# BMW Motorrad USA

## Service Information Bulletin

### \*\*Technical Campaign\*\*

**Subject: Clutch slave cylinder**

Illustration: Clutch slave cylinder

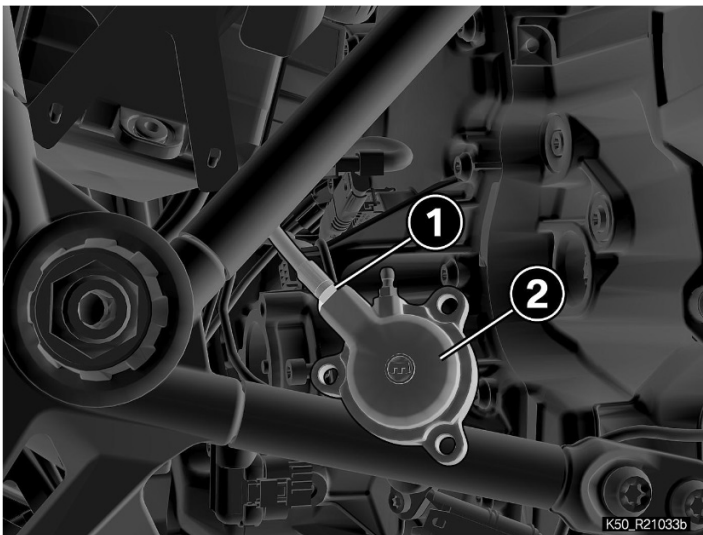
**Details:** BMW Motorrad has determined in the course of quality observation that in a few cases clutch fluid may leak between the clutch slave cylinder and the braided stainless steel clutch line. The cause is a burr in the clutch slave cylinder which may damage the gasket of the clutch line. A vehicle with high mileage can show signs of gradual impairment of the clutch function. The separating action of the clutch can worsen gradually over a period of time.

**Production Solution:** A clutch slave cylinder with correct chamfer for the gasket of the braided stainless steel clutch line has been installed in production since 10/17/2015.

**Service Solution:** Before delivery or as part of the next workshop visit for the motorcycles affected, a new clutch slave cylinder is to be installed and the O-ring of the braided stainless steel clutch line is to be renewed.
